Subject: Communications Report Transmittal #11
Comanche Peak Steam Electric Station
Independent Assessment Program - Phase 4
Texas Utilities Generating Company
Job. No. 84056

Communications Report

Company:	Texas Utilities	<input checked="" type="checkbox"/> Telecon	<input type="checkbox"/> Conference Report
Project:	Comanche Peak Steam Electric Station Independent Assessment Program - Phase 4	Job No.	84056
		Date:	10/9/84
Subject:	Cable Tray and Conduit Support Design Status of Specific Question as of 10/9/84	Time:	2:45 p.m.
		Place:	CES-SFRO
Participants:	J. VanAmerongen	of	TUGCO (EBASCO)
	P. Huang, T. Keiss		Gibbs & Hill
	J. Russ, W. Horstman, N. Williams		Cygna

FIGURE 1

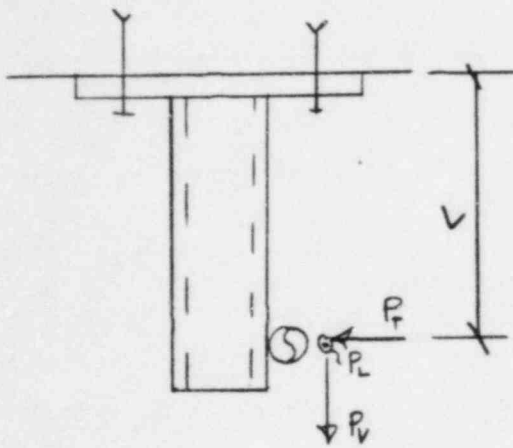
5.	<p>Cygna asked if the load case of Figure 2 from Item 3 above had been considered in the design of CSM-42a. Mr. Kissinger and Mr. Russ then reviewed calculation SCS-209C, Set 3. The calculation considered all loading configurations. Cygna also asked about the effect of concrete compressive forces in the bolt design. Mr. Kissinger stated such calculations would be included with the calculation for support IN-CSM-15a.</p>

Therefore, this shows that the loads for the condition in Figure 2 are 1/2 the magnitude of Figure 1. Considering the vector magnitude, the design is adequate.

FIG. II-II-1 RECOMMENDED MINIMUM LENGTHS OF PIPE PRECEDING AND FOLLOWING ORIFICES, FLOW NOZZLES AND VENTURI TUBES (ALL CONTROL VALVES, INCLUDING REGULATORS, SHOULD BE LOCATED ON OUTLET SIDE OF PRIMARY ELEMENT.)

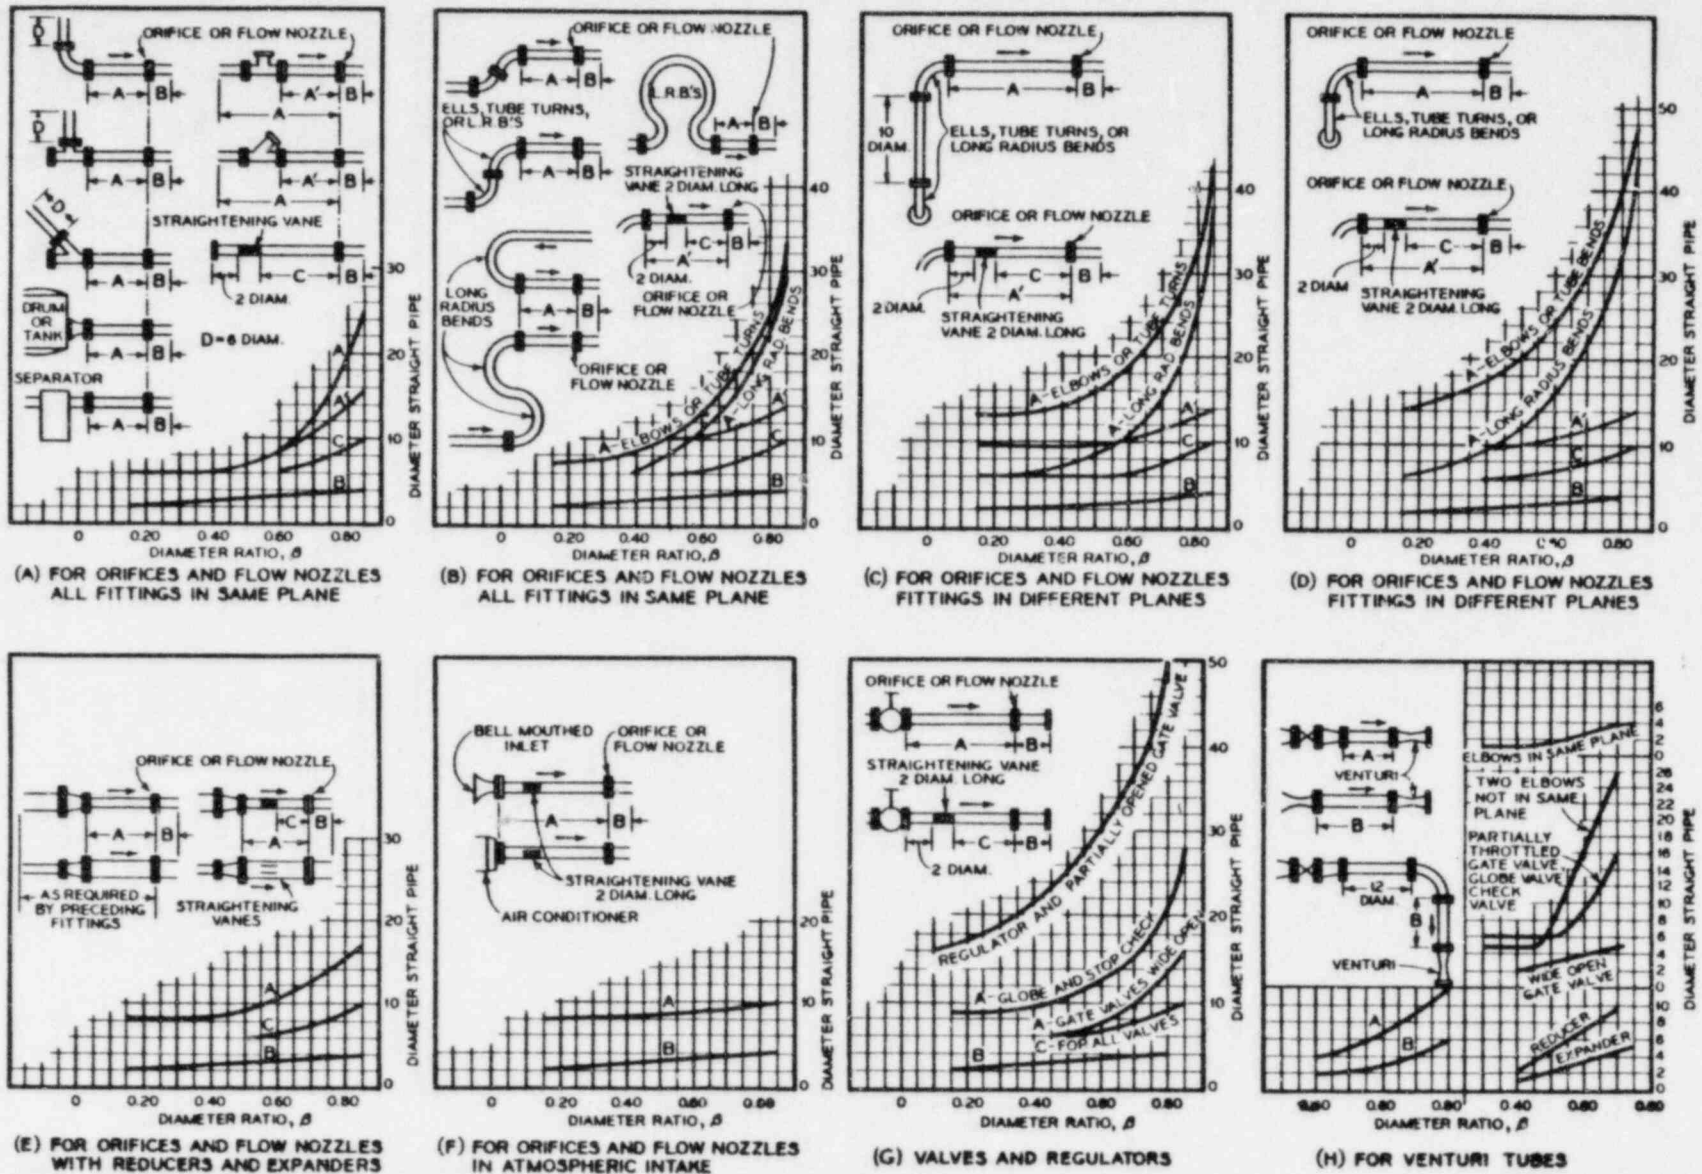
Item	Comments	Required Action By
1)	In response to our earlier question on orifice installation requirements Wanda gave us the attached installation standards.	
2)	She said that the I&C engineer stated that everybody uses the same criteria and all vendors requirements are the same. In other words the G&H criteria is industry standard. If we have additional questions the I&C engineer would be available to discuss the matter with us.
